Yandicoogina iron ore mine and railway

Hamersley Iron Pty. Limited

**Report and recommendations
of the Environmental Protection Authority**

**Environmental Protection Authority
Perth, Western Australia
Bulletin 809
April 1996**

Figure 4. Proposed route of the Central Pilbara railway extension. (Source: Hamersley, 1995)

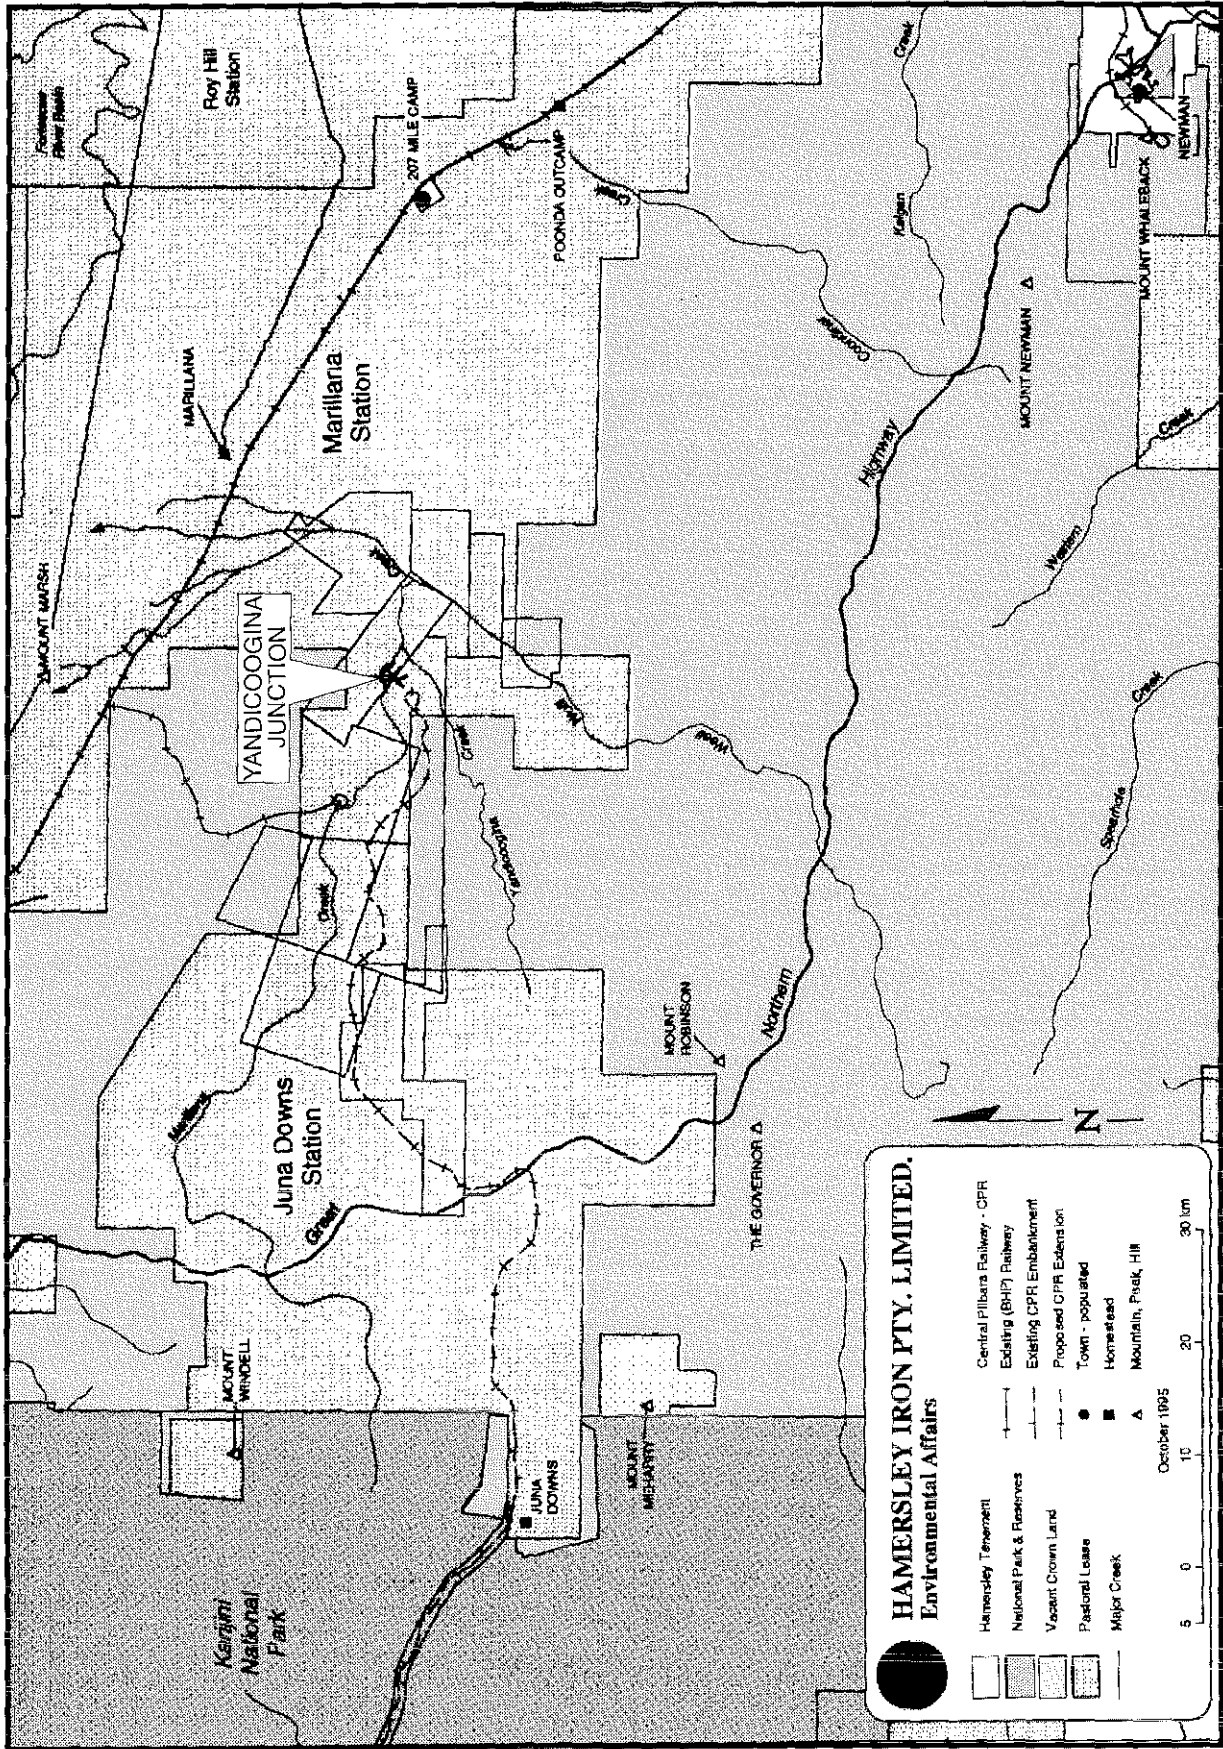
Q4.2 Detailed consideration needs to be given to low level drainage in the area of extensive high quality mulga flats where the railway crosses the Great Northern Highway. Sheet CPR6 shows that the rail corridor will cut drainage to the mulga from the hills to the north. In the absence of appropriate drainage control, severe damage may be inflicted on this area. Plans for the drainage management should be reviewed and approved by DEP and CALM.

Q4.3 The CER contains no description of culvert/bridge design or their location. There is also no indication of how sheet flood will be managed in the Juna Downs section as it tries to move southwards into the upper reaches of the Yandicoogina creek or how the bridge is going to be built over that same river, but relies on the statement that rail construction will be of the same high standard as that of the construction of the Central Pilbara Railway. This is not satisfactory.

Final railway plans will be submitted to the DEP and CALM for approval. These plans will show the drainage controls proposed along the length of the railway alignment.

There is no bridge proposed to be constructed over Yandicoogina Creek. The railway alignment is separated from Yandicoogina Creek by high terrain and therefore never crosses it, or extensive sections of its catchment (refer Figure 3.2 of the CER). The nearest structure associated with the project that is located on or near Yandicoogina Creek is the mine water discharge point; the nearest other structure is the load-out conveyor, located about 2 km from Yandicoogina Creek (refer Figure 3.1 of the CER). The conveyor will be elevated well above known flood levels where it crosses Marillana Creek.
